NOTICE OF NON-PERFORMANCE

INSPECTION REPORT

Electrical Corporation:	PacifiCorp
Report Number:	PAD_PC_IAG_20251007_0944
Inspector:	Ivan Garcia
WMP Year Inspected:	2025
Quarterly Data Report (QDR) Referenced:	Quarter 2 (Q2)
Inspection Selection:	Energy Safety viewed the contents of the Q2 QDR and performed an analysis that resulted in the selection of the WMP initiatives and locations referenced in this report.
Relevant WMP Initiative(s):	8.1.2.12 - Expulsion Fuse Replacements
Date of inspection:	October 7, 2025
City and/or County of Inspection:	Montague, Siskiyou County
Inspection Purpose:	Assess the accuracy of PacifiCorp's QDR data, completeness of its work, and performance of WMP requirements.

Exhibit A: Photo Log

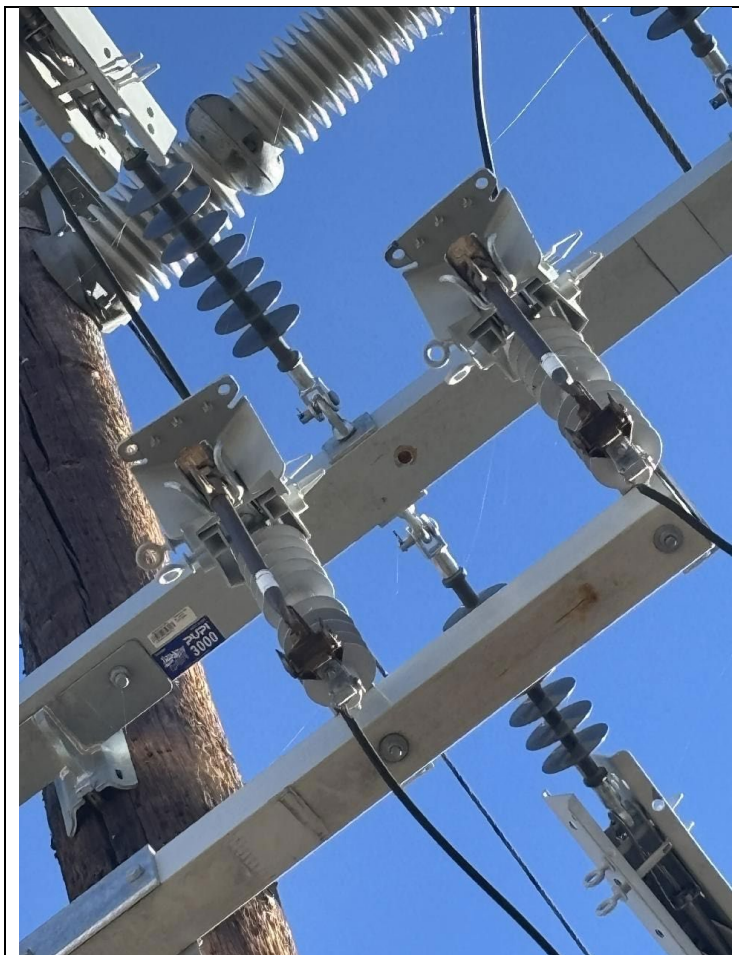
On pole with work associated with Grid Hardening ID 7112939 at 2534-2698 E Oberlin Rd, Montague, 96064, USA, 41.71146536840899, -122.59407909092792, the inspector observed California Department of Forestry and Fire Protection (CAL FIRE)-approved non expulsion fuses were not installed. The inspector's observation is documented in Deficiency 1 photographs, which are attachments to this report. Photo number IA1Img1 depicts incomplete installation of CAL FIRE-approved non expulsion fuses. In the 2025 Q2 Quarterly Data Report submission, PC reported that work on WMP initiative 8.1.2.12 – Expulsion Fuse Replacements were completed at this location.

1. CAL FIRE-approved non expulsion fuses were not installed at the subject pole.
2. The inspector observed solid blade disconnects on the subject pole.
3. No reclosers, sectionalizers, or voltage regulators were observed at the subject pole.

IA1Img1: Solid blade disconnects installed

Deficiency 1. Energy Safety observed that in implementing 2025 WMP initiative 8.1.2.12 - Expulsion Fuse Replacements, PC failed to complete the installation of CAL FIRE-approved non expulsion fuses on a pole with work associated with Grid Hardening ID 7112939 at coordinates 41.71146536840899, -122.59407909092792. Energy Safety considers this non-performance to be in the Minor risk category. PC must complete a corrective action for this deficiency by 12 months from date of this notice.¹
